STAFF REPORT

RE: **CD-CPC-2019-00080 – Master Planned Development (MPD)
"District Row"**

REQUESTS: For a rezoning from Districts R-1.5 and M1-5 to District MPD with preliminary development plan a Master Planned Development area for "District Row" – consisting of 35 townhome dwelling units and the redevelopment of the "Western Bible College" historic building in to a mixed use education and office facility.

Section 88-323-03-B.6 Vehicular Use Areas along a Boulevard

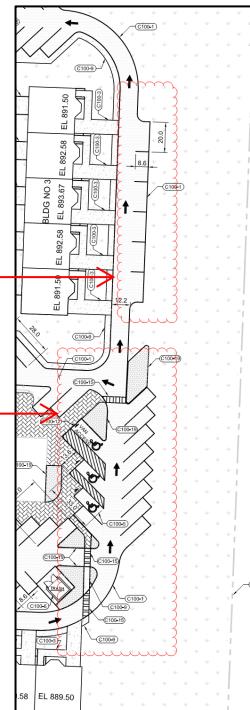
- Proposed: Currently the plan shows a vehicular use area to the east of the northern townhome area and east of the existing Western Bible College building.

- Staff Recommendation: Staff understands the need for the vehicular drive lines per fire code access to the structures and general traffic flow to the site. However, staff does not support the location of the parallel parking east of the townhomes or the angled parking east/behind the Western Bible College building. These should be relocated elsewhere on site and meet the intent of the Boulevard and Parkway Standards. **Update since CPC: the developer shall obtain a Variance from the BZA in order to allow any part of the vehicular use area adjacent to The Paseo.**

6. Staff recommends a deviation to the Boulevard and Parkway Standards to allow for drive lanes only between the existing Western Bible College and proposed townhome and the Paseo. **Staff recommends this condition be amended as the revised plans now show this driveway to read as follows:** The applicant shall obtain a variance from the Board of Zoning Adjustment to the park Boulevard and Parkway Standards to allow for vehicular use area between the existing Western Bible College and proposed townhome and The Paseo.

PARKLAND DEDICATION:

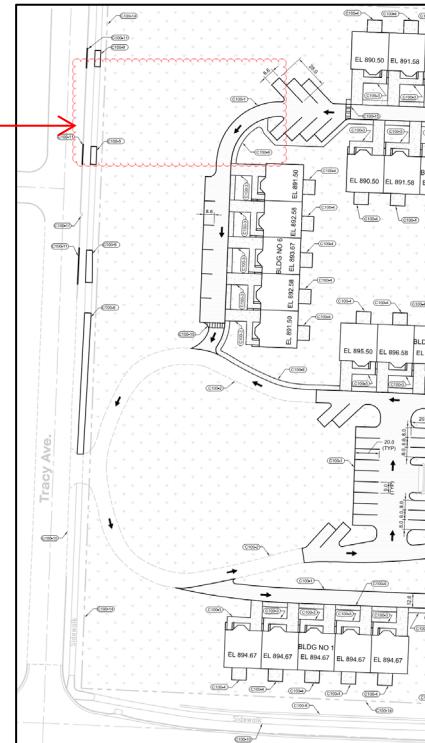
Section 88-408 of the Zoning and Development Code dictates all new residential developments are required to either dedicate public park space, private open space with amenities, or pay a fee in lieu of such dedications. The submitted plan does not demonstrate which options or combination of options will be used for the development. Based on the additional 35 townhome dwelling units at total of 0.42 acres dedicated (35 d/u x 2 people per unit x 0.006 multiplier = 0.42 acres).

35. Provide the following language on the plat: PAYMENT IN LIEU OF PARKLAND: The developer elects to pay the City of Kansas City, Missouri, a sum of \$24,959.02 in lieu of required parkland dedicating for (# single family units, duplex units, multi-family units) pursuant to Section 88-408-C of the Zoning and Development Code. Money in lieu of parkland for 2020 shall be based on the following formula: (35 multi-family units) X (2 persons per unit) X (0.006 acres per person) = 0.42 acres of parkland required X 2019 parkland fee of \$48,801.37 per acre = Fee in lieu of \$24,959.02.
